## INSPECTION REPORT

**Permit Number:** PRCCP20241109

**Property Address:** 3303 8TH AVE SE, Unit: E, PUYALLUP, WA 98372;

**To construct:** This project will remodel and expand an existing auxiliary building to provide classrooms, outdoor learning spaces, administrative space, and office space. The project will be constructed over stormwater treatment BMPs that were installed to provide runoff treatment for the parking area installed during the 2018 Germaine Korum Center project. Therefore, this project will need to redesign/add runoff treatment BMPs to the existing parking area to replace the impacted treatment BMPs. See the attached Project Description. STEP BY STEP - ELC AND ADMINISTRATIVE OFFICES FACILITY

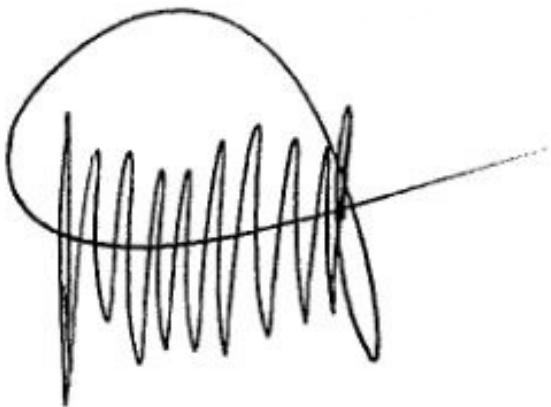
1. 1. Repair ditch E&W of 33rd where sewer went through.
2. Install sewer marking board per COP detail 04.03.02.
3. Remove all silt fence.
4. North side of driveway off 33rd needs gravel removed. Install grass seed and a heavy layer of straw. 1' gravel should remain only.
5. Clean up laydown yard west of 33rd. Install grass seed and a heavy layer of straw. DO NOT GRAVEL this area!
6. Clean asphalt.
7. After asphalt is cleaned and all landscape has been completed, silt socks may be removed.
8. Install all CB lid bolts.
